Subject: Submittal of Formal Revision 4 of the NUHOMS® HD System Safety Analysis Report (TAC NO. L23738).

TN Response to NRC Peer Review Comments on the
NUHOMS[®] HD System

**NUHOMS HD Peer Review Comments
December 7, 2005**

Summary of Changes Implemented in SAR Revision 4 and Supporting Reason for Change

Figure 3-2
Finite Element Model and Boundary Conditions WE 15x15 and WES 15x15

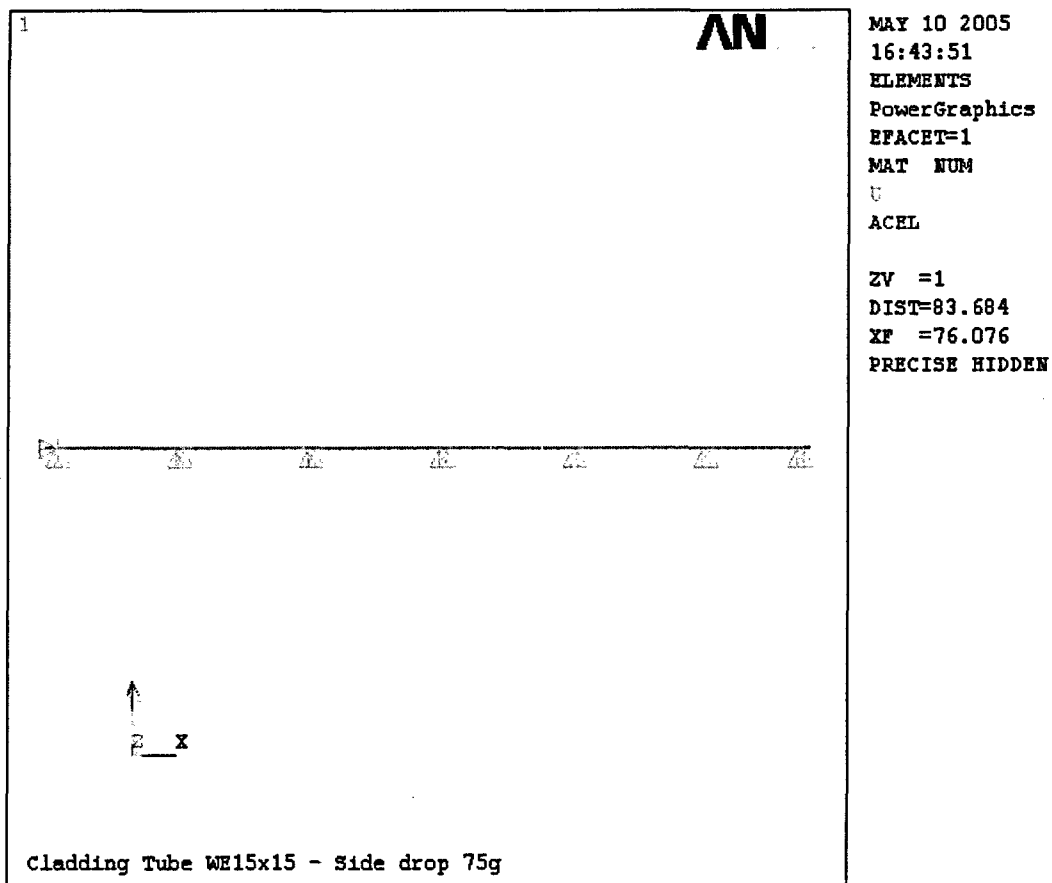
Table 3-13	Response to RAI#2 and consistent fuel type abbreviation call out (comment from Peer Review #1)
Figure 3-2	Response to RAI#2 and consistent fuel type abbreviation call out (comment from Peer Review #1)
Figure 3-3	Response to RAI#2 and consistent fuel type abbreviation call out (comment from Peer Review #1)
Figure 3-4	Response to RAI#2 and consistent fuel type abbreviation call out (comment from Peer Review #1)
Figure 3-5	Response to RAI#2 and consistent fuel type abbreviation call out (comment from Peer Review #1)
Figure 3-6	Response to RAI#2 and consistent fuel type abbreviation call out (comment from Peer Review #1)
Figure 3-7	Response to RAI#2 and consistent fuel type abbreviation call out (comment from Peer Review #1)

Figure 4-39
Comparison of the Axial Heat Profiles in the FE Model and in Ref. [4]

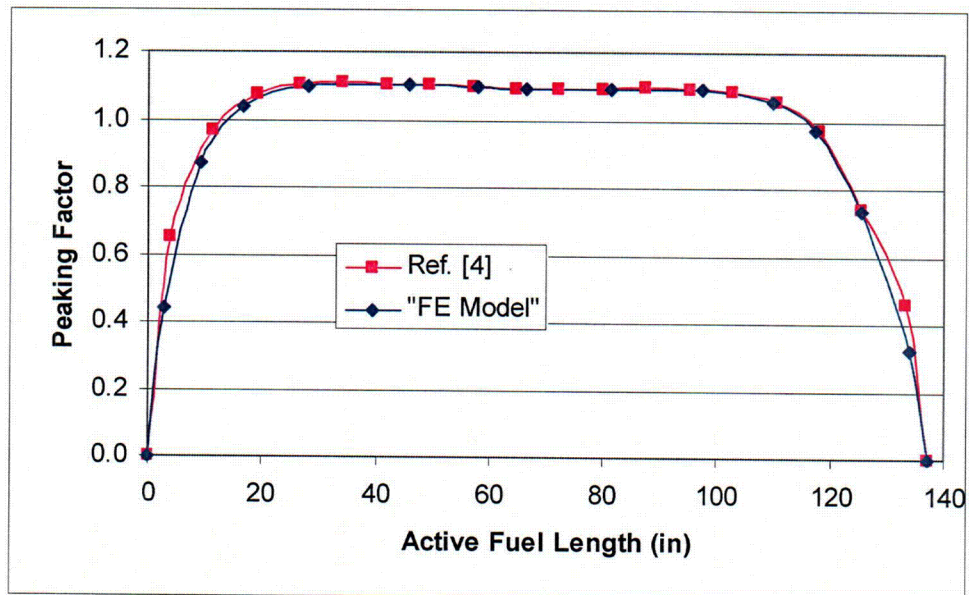
Figures 4-39, 4-47,	Consistent fuel type abbreviation call out (comment from Peer Review #1)
5-ii	Consistent fuel type abbreviation call out (comment from Peer Review #1), typo
5-1	Consistent fuel type abbreviation call out (comment from Peer Review #1)
5-3	Typo (change ENDFB-IV to ENDF/B-V)
5-4	Consistent with Technical Specifications and fuel type abbreviation call out (comment from Peer Review #1)
5-5	Typo (change ENDFB-IV to ENDF/B-V) and fuel type abbreviation call out (comment from Peer Review #1)
Table 5-7	Consistent fuel type abbreviation call out (comment from Peer Review #1)
Table 5-9	Consistent fuel type abbreviation call out (comment from Peer Review #1)
Table 5-10	Consistent fuel type abbreviation call out (comment from Peer Review #1)
Table 5-13	Consistent fuel type abbreviation call out (comment from Peer Review #1)
6-ii	Typo
Table 6-1	Consistent with Technical Specifications
Table 6-3	Consistent fuel type abbreviation call out (comment from Peer Review #1) and consistent with Technical Specifications

Figure 7-1
32PTH DSC Confinement Boundaries and Welds

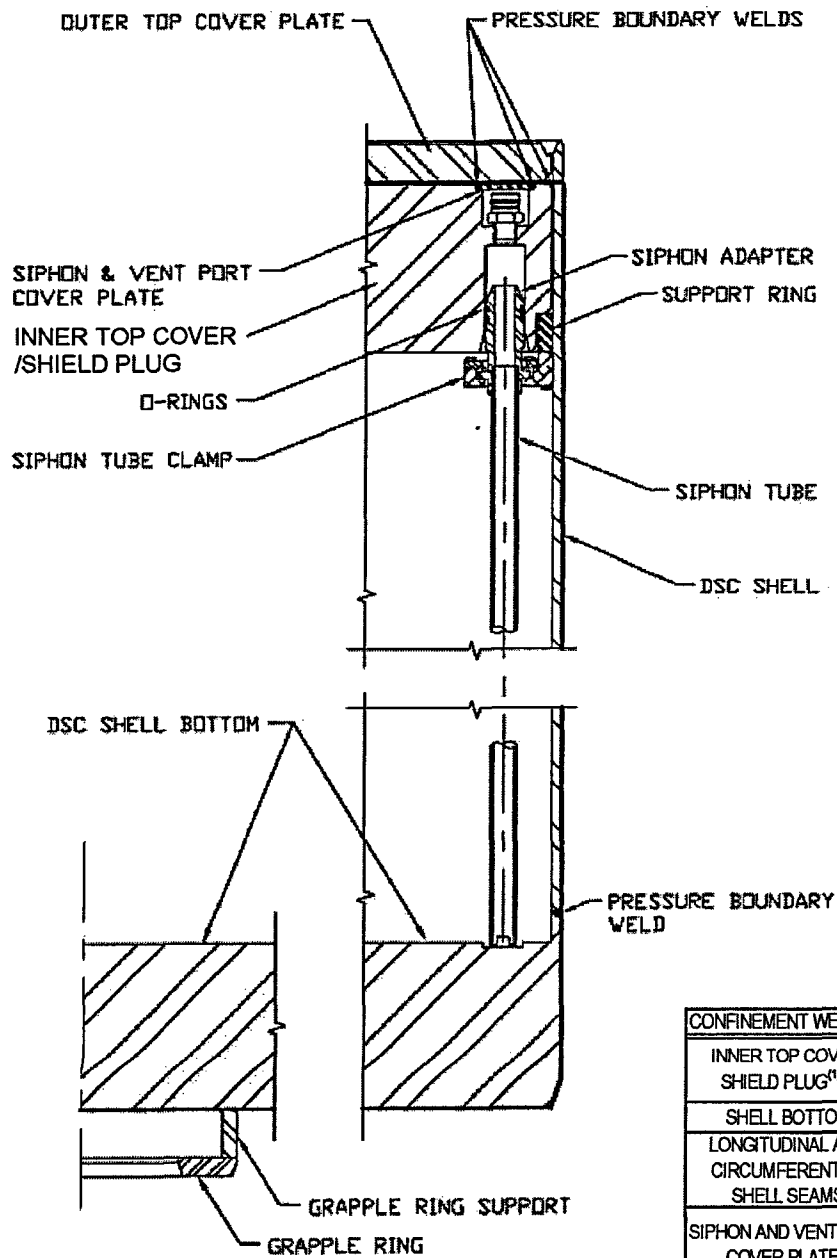
Page Number	Change Description and Reason for Change
7-5	Remove Code Case N-595-3 (comments from Peer Review #23 and #32)
Figure 7-1	Editorial change and add detail description of confinement boundary welds (Action per 11/18/05 telcon with NRC Staff)
8-1	Replace air with nitrogen; response to Peer Review Comment #15, typo
8-2	Response to Peer Review Comments #5 and #10
8-3	Replace air with nitrogen; response to Peer Review Comments #9 and #11; editorial change, add note 1
8-4	Replace air with nitrogen; response to Peer Review Comments #6, #15, and #35; editorial correction; terminology consistency
8-5	Response to Peer Review Comment #6; action per 11/18/05 telcon with NRC Staff for adding pressure test of inner cover/shield plug to shell weld; editorial changes
8-6	Replace air with nitrogen; Action per 11/18/05 telcon with NRC Staff; editorial correction; response to Peer Review Comments # 12 and #35

Figure 12-2
Heat Load Zones

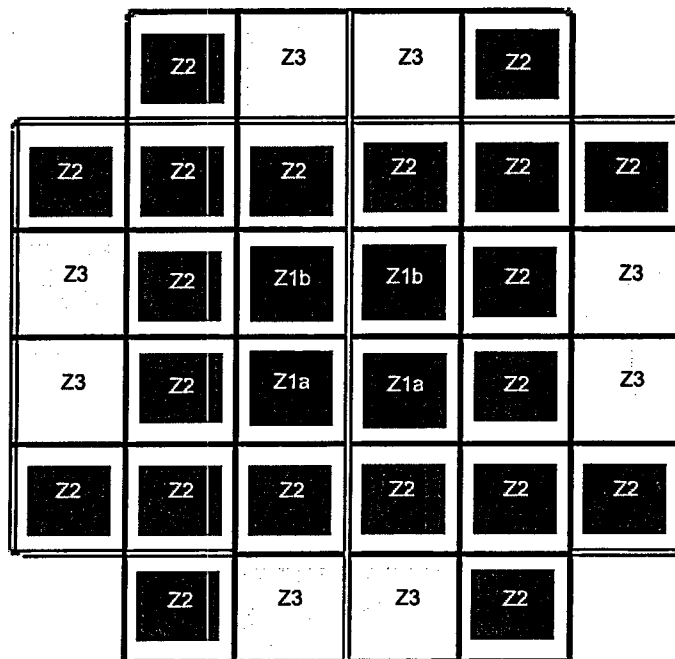
Page Number	Change Description and Reason for Change
Figure 12-2	Consistent with Technical Specifications
B12-9	Replace air with nitrogen
B12-10	Response to Peer Review Comment #6
B12-11	Replace air with nitrogen and clarity regarding "inner top cover/shield plug" for consistency
B12-13	"Annulus" deleted for consistency, an editorial correction, and clarity regarding "inner top cover/shield plug"
B12-14	"Annulus" deleted for consistency
Chapter 13 pages 13-i, 13-1, 13-2, 13-3, 13-5 through 13-8, 13-10, and Table 13-1	Consistent with current Quality Assurance Program Description Manual
